Reference: U.S. Geological Survey TRIGA Reactor (GSTR), Docket 50-274, License R-113, Request for Additional Information (RAI) dated March 21, 2012

Subject: Responses to Questions 26 and 27 of the Referenced RAI

HotSpot Version 2.07 General Plume

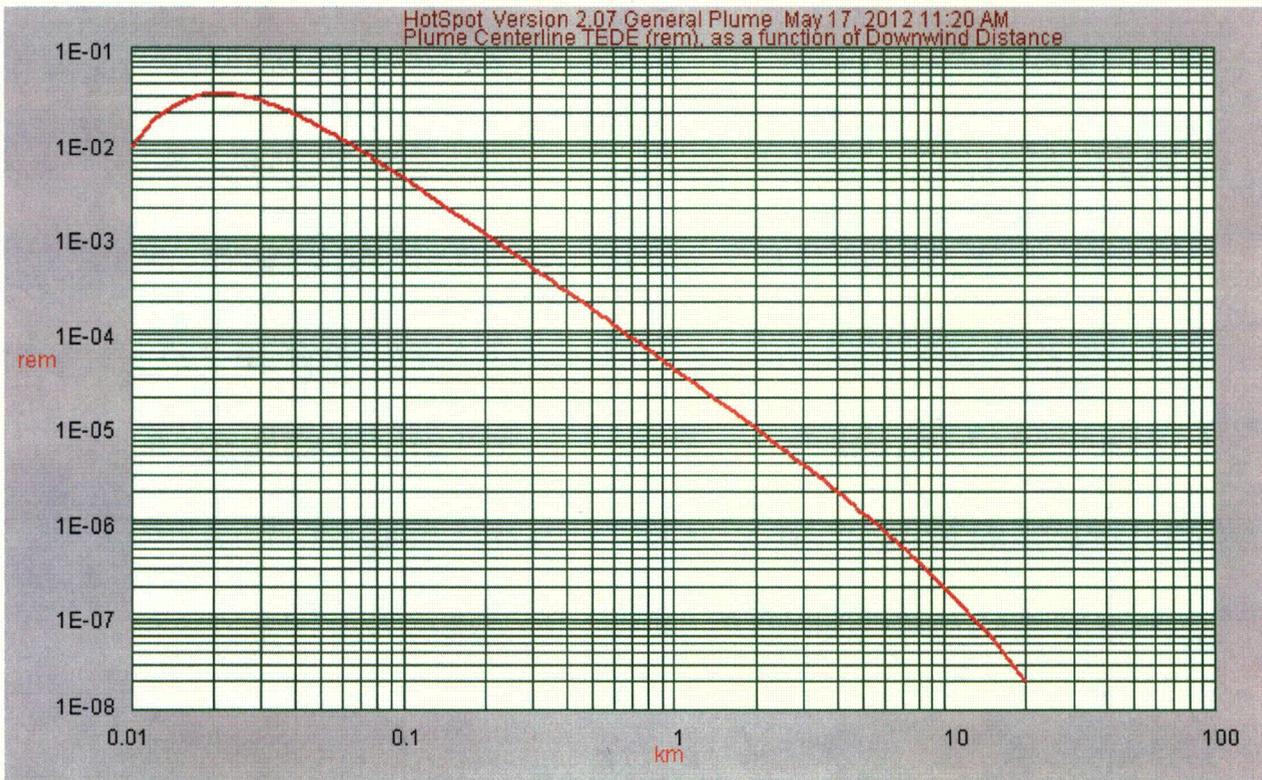
- d. USGS SAR, Section 11.1.1.1.1 describes the routine exposure of personnel in unrestricted areas from Ar-41 releases assuming the person is standing next to the reactor building, at a distance of 8 meters from the release point. An annual release of 25 Ci of Ar-41 results in an whole body dose of less than 17 mrem per year a person near the building wall. Please provide the assumptions, calculations, and justification supporting the estimation of doses in the unrestricted area from annual operational releases of AR-41 to the atmosphere.

The scenario of an annual 25 Ci release of Ar-41 was reanalyzed using the DOE HOTSPOT computer code (version 2.07), general plume model. This analysis made conservative assumptions about meteorological conditions, release amount, and the location of the receptor at the maximum dose point. The results are given below, showing input parameters and a graph of the dose versus downwind location. It is conservatively assumed that the receptor is always downwind of the release point and at the center of the plume, for the entire year. The downwind distance for the maximum dose is 34 meters and the maximum dose is 7.4 mRem.

Source Material : Ar-41 1.827h
Material at Risk : 2.5000E+01 Ci
Damage Ratio : 1.000
Leakpath Factor : 1.000
Airborne Fraction : 1.000
Respirable Fraction : 1.000
Respirable Release Fraction: 1.000
Physical Stack Height : 6.4 m
Stack Exit Velocity : 10.10 m/s
Stack Diameter : 0.2 m
Stack Effluent Temp. : 20.0 deg C
Air Temperature : 20.0 deg C
Effective Release Height : 6.40 m
Wind Speed (h=10 m) : 3.84 m/s
Distance Coordinates : All distances are on the Plume Centerline
Wind Speed (h=H-eff) : 3.72 m/s
Stability Class : B
Respirable Dep. Vel. : 0.30 cm/s
Non-respirable Dep. Vel. : 8.00 cm/s
Receptor Height : 1.5 m
Inversion Layer Height : None
Sample Time : 10.000 min
Breathing Rate : 3.33E-04 m3/sec

Maximum Dose Distance : 0.034 km

MAXIMUM TEDE : 7.41E-03 rem

HotSpot Version 2.07 General Plume

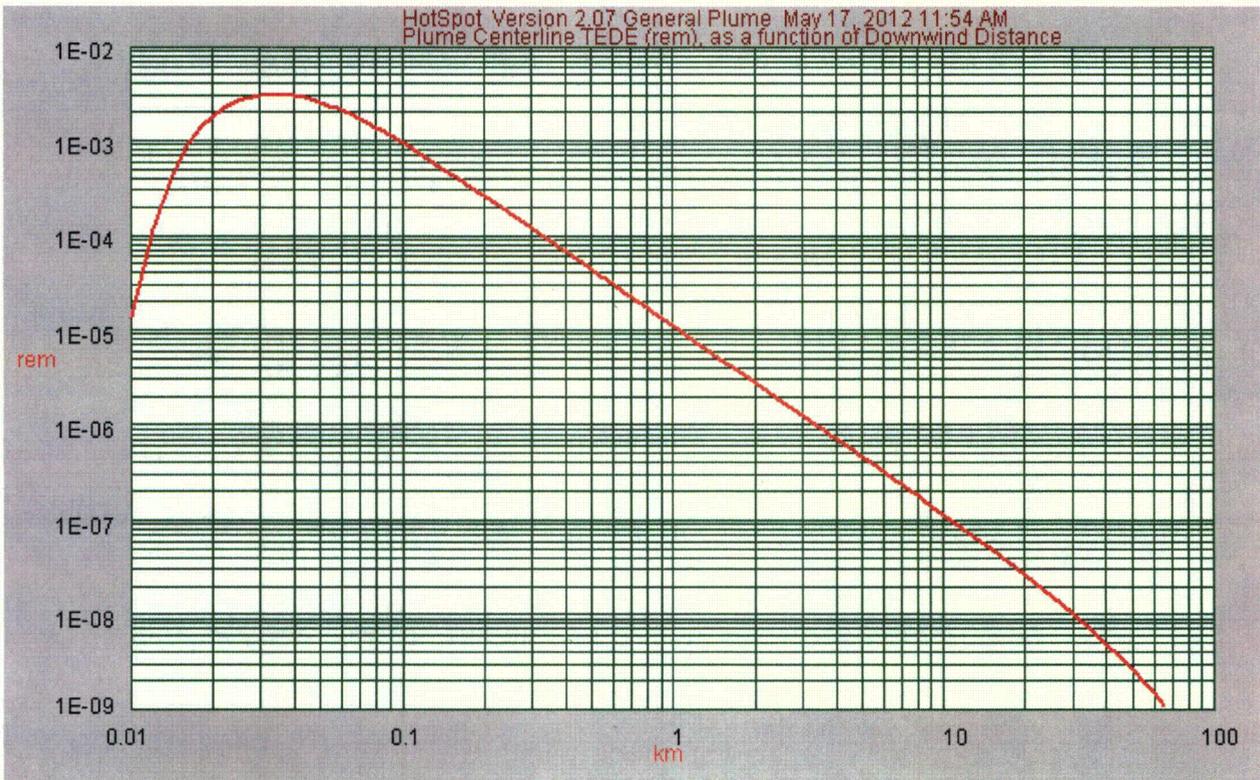
- e. USGS SAR Section 11.1.1.1.4 discusses the estimation of offsite doses from routine releases of Ar-41. Please provide a reference and justification for the use of Equation 11.31 for estimating ground level concentrations of Ar-41 including the basis for the average air concentration during operations of 5.85×10^{-6} μCi per cubic meter. Please provide an evaluation of your analysis to meeting the regulatory limit cited in 10 CFR 20, Appendix B in units of $\mu\text{Ci}/\text{mL}$, and an estimate of the dose to a member of the public.

The evaluation of the Ar-41 dose estimate to the public was recalculated using the DOE HOTSPOT computer code (version 2.07), general plume model. A nominal exhaust flow of 3.17×10^5 ml/s along with a full power reactor exhaust air concentration of 4.35×10^{-6} $\mu\text{Ci}/\text{ml}$ results in 1.38 $\mu\text{Ci}/\text{s}$ released during full power operation. Conservatively

assuming 1560 hours of operation a year (6 hours a day and 5 days a week) at full power results in a total release of 7.75 Ci of Ar-41 for the year.

The nearest unrestricted public access point is 350 meters from the Ar-41 release point and the nearest public residence is 640 meters from the release point. The HOTSPOT results are given below, showing input parameters and a graph of the dose versus downwind location. The dose at a distance of 350 meters downwind of the release point is 0.067 mRem and the dose at a distance of 640 meters downwind of the release point is 0.020 mRem. These annual doses are far below any NRC limits for members of the public.

Source Material : Ar-41 1.827h
 Material at Risk : 7.7500E+00 Ci
 Damage Ratio : 1.000
 Leakpath Factor : 1.000
 Airborne Fraction : 1.000
 Respirable Fraction : 1.000
 Respirable Release Fraction: 1.000
 Physical Stack Height : 6.4 m
 Stack Exit Velocity : 10.10 m/s
 Stack Diameter : 0.2 m
 Stack Effluent Temp. : 20.0 deg C
 Air Temperature : 20.0 deg C
 Effective Release Height : 6.40 m
 Wind Speed (h=10 m) : 3.84 m/s
 Distance Coordinates : All distances are on the Plume Centerline
 Wind Speed (h=H-eff) : 3.72 m/s
 Stability Class : B
 Respirable Dep. Vel. : 0.30 cm/s
 Non-respirable Dep. Vel. : 8.00 cm/s
 Receptor Height : 1.5 m
 Inversion Layer Height : None
 Sample Time : 10.000 min
 Breathing Rate : 3.33E-04 m3/sec
 FGR-11 Dose Conversion Data - Total Effective Dose Equivalent (TEDE)

DISTANCE km	TEDE (rem)
0.350	6.7E-05
0.640	2.0E-05
